**MEETING AGENDA**  
CITY PLAN COMMISSION  
Thursday, October 8, 2026

**VA-26-005    Vacation of a Portion of the Sandshell Boulevard Right-of-Way, North of Basswood Boulevard and Waiver Request Section 31-63(e)(6)(a): Street Vacation Recommendation Expiration: Council District 4.**

# PRELIMINARY PLAT FOR NANCE RANCH

## Vacation Exhibit (To be revised)

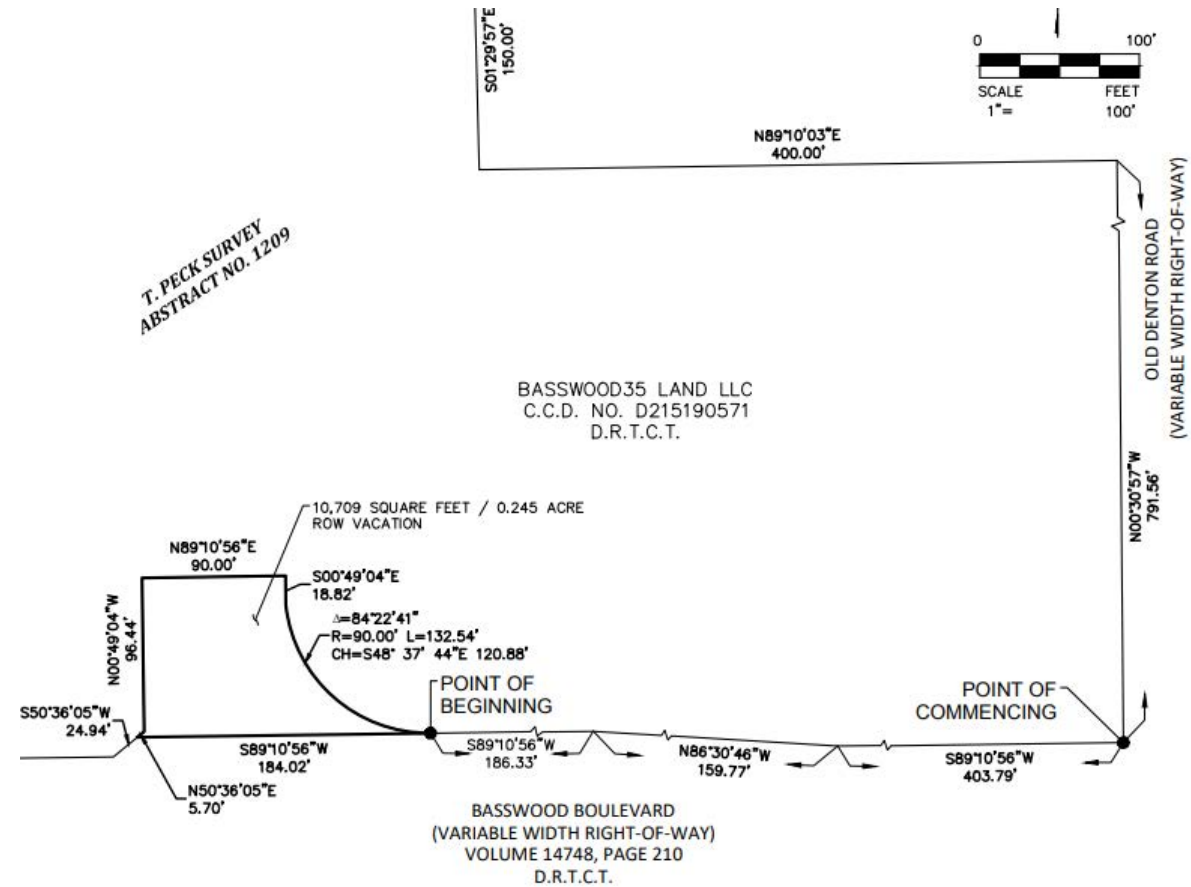
- DRC Comments: Transportation cannot recommend approval until updated exhibit is submitted retaining RoW for future traffic signals at Basswood/Sandshell intersection.
- DRC recommends: (1) Denial of a recommendation to the City Council for the vacation of a portion of Sandshell Boulevard right-of-way; and (2) Denial of a waiver to Section 31-63(e)(6)(a) of the Subdivision Ordinance to waive the requirement that a replat be submitted within 180 days of Plan Commission's recommendation.
- *Applicant requested to withdraw the case after discussion with staff on 10/2.*

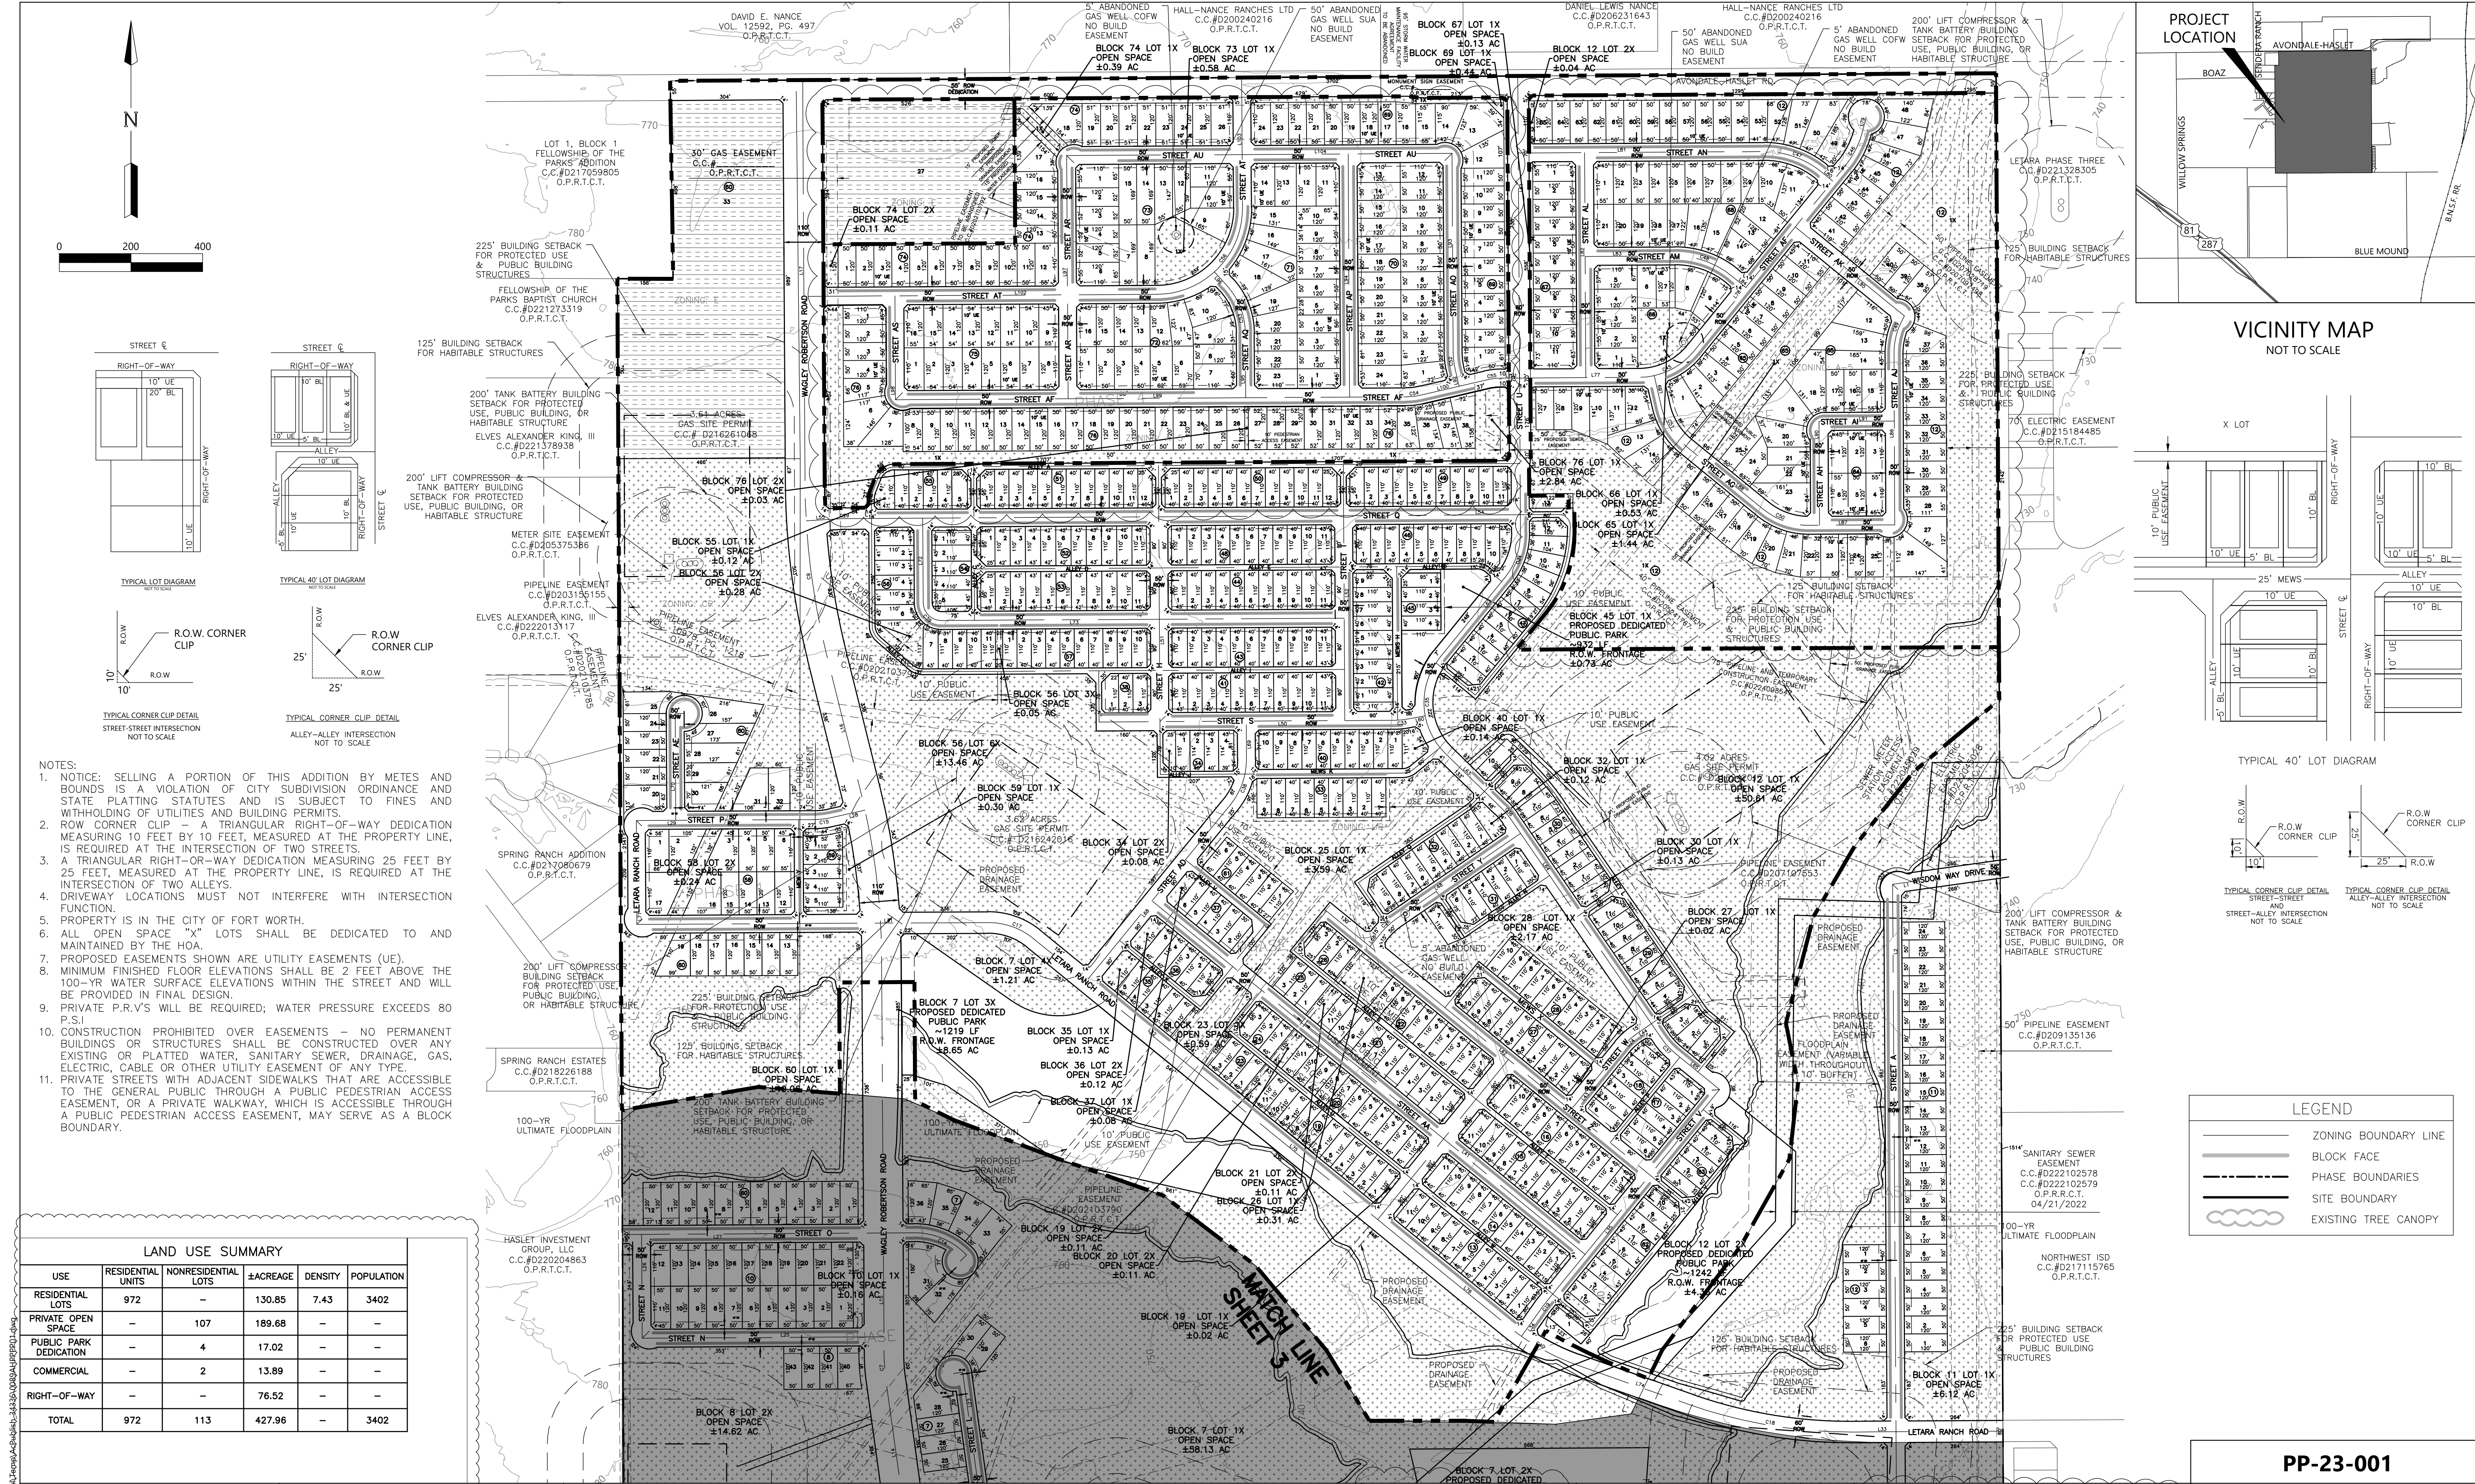
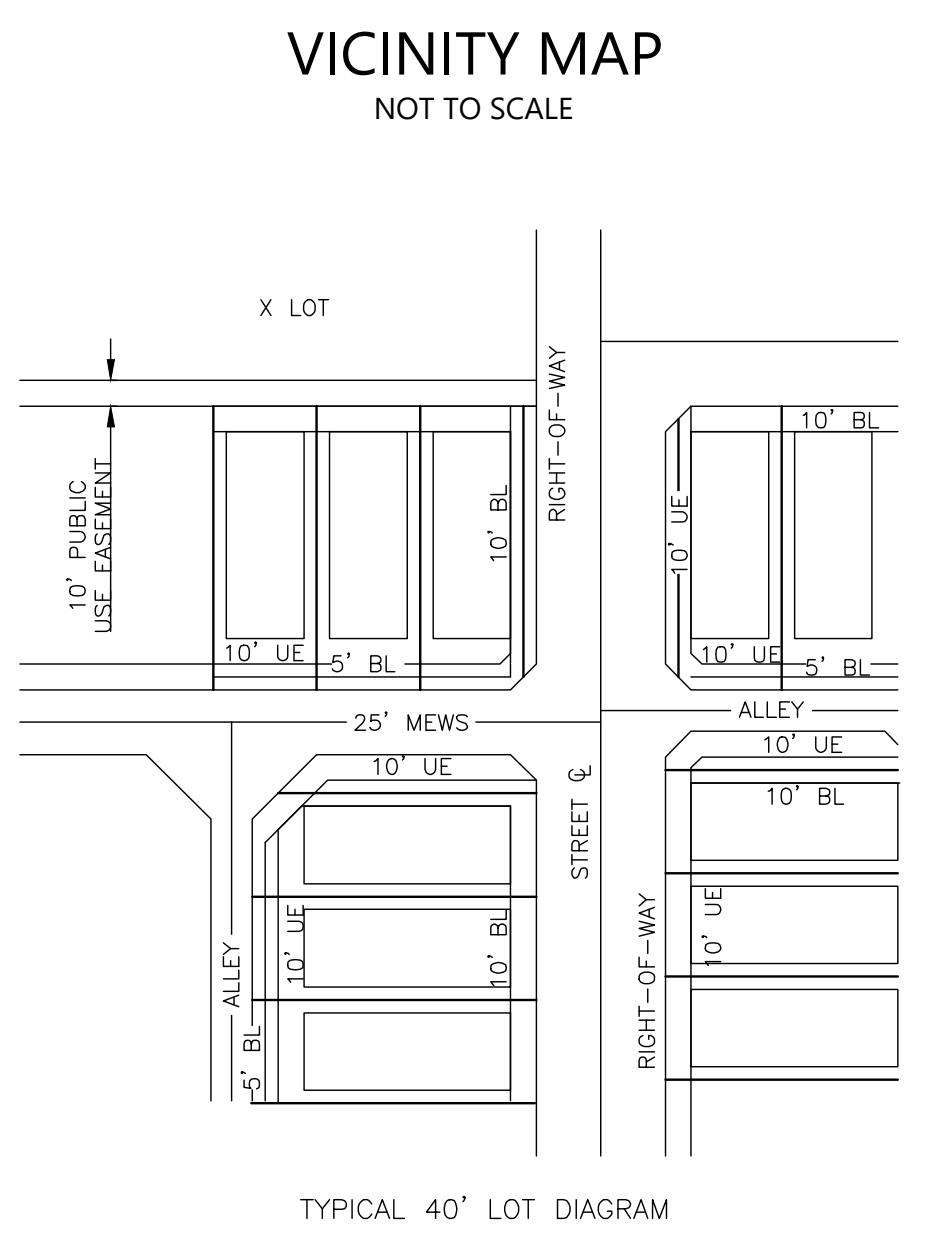
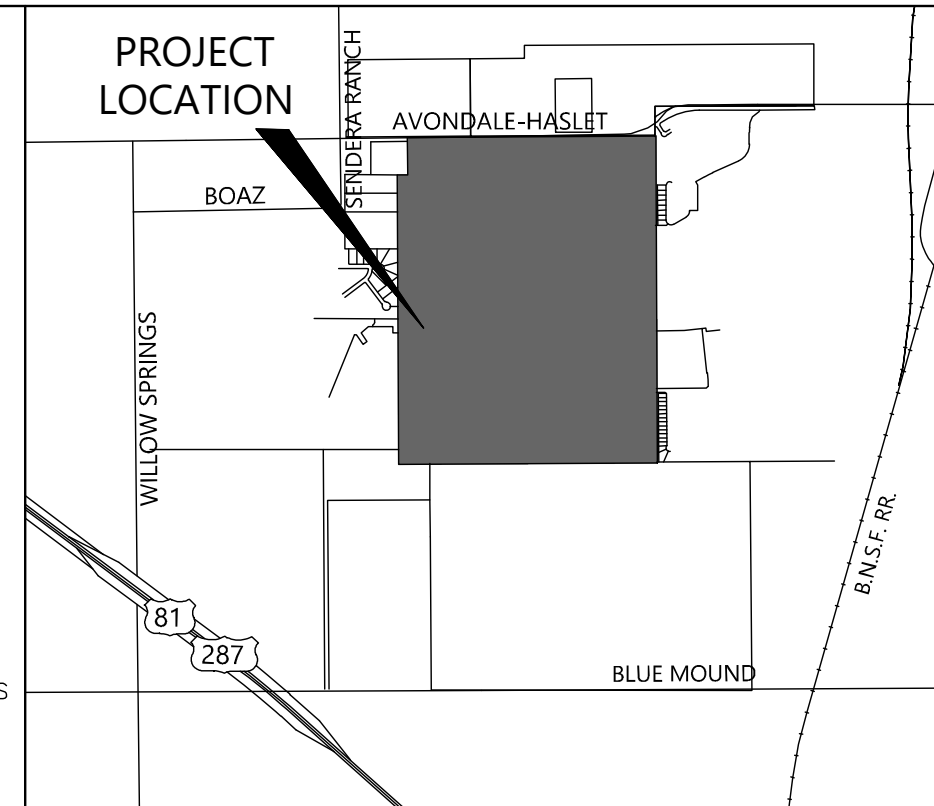
1. An additional long block face has been added to the development that exceeds the maximum allowed distance of 1,320 feet. The block face that extends from Lot 12-41, Block 12 exceeds this maximum distance. A waiver from City Plan Commission is required.

1. The preliminary plat revision has created a block face (Block 76 from Lot 1 to 1X) that exceeds the maximum allowed distance of 1,320 feet per Section 31-106(d)(2). Either a redesign or waiver request from City Plan Commission is required.

The proposed street network maintains adequate connectivity and circulation for local traffic. An access easement and sidewalk have been added through the long block to improve connectivity to the phase to the south. Traffic volumes are expected to remain low and consistent with a local residential street classification, and emergency vehicle access is preserved. No adverse impacts to public safety or traffic operations are anticipated as a result of the increased block length.
